MECHANICAL FAUCETS

Shop Drawing Submittal Review

Project Name: Webster University-**ISB**

SPEC SECTION: 22 4216.16
Commercial Sinks

895-317ABCP

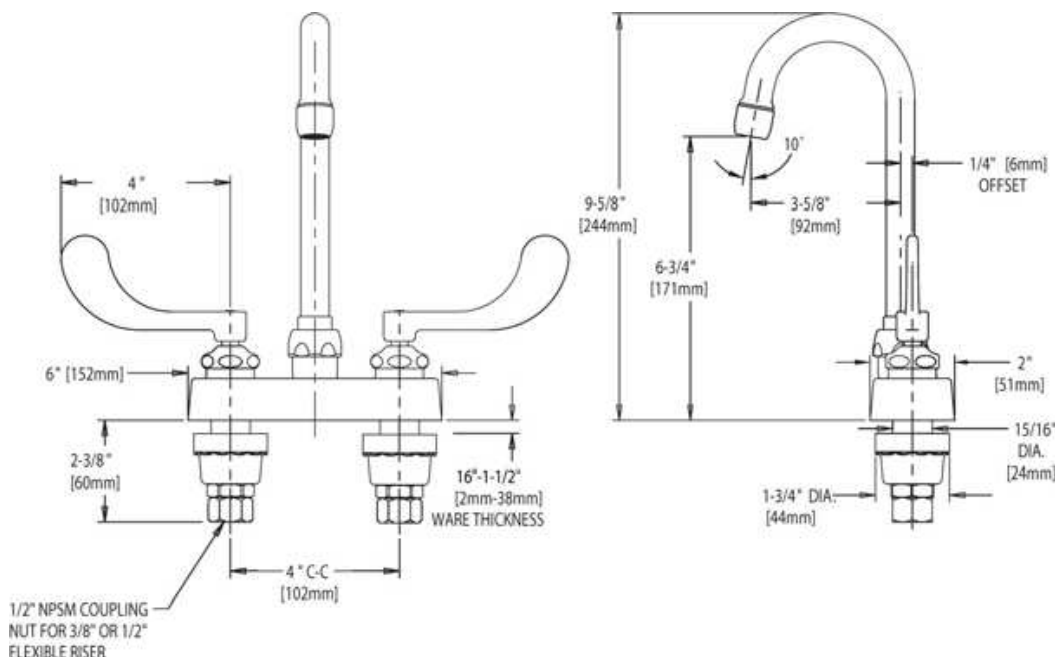
1. Provide under counter waste and supply protective piping covers as required.
Verify requirements with the architectural drawings.
2. Escutcheons are specified to be cast brass. Refer to specification section 220518.
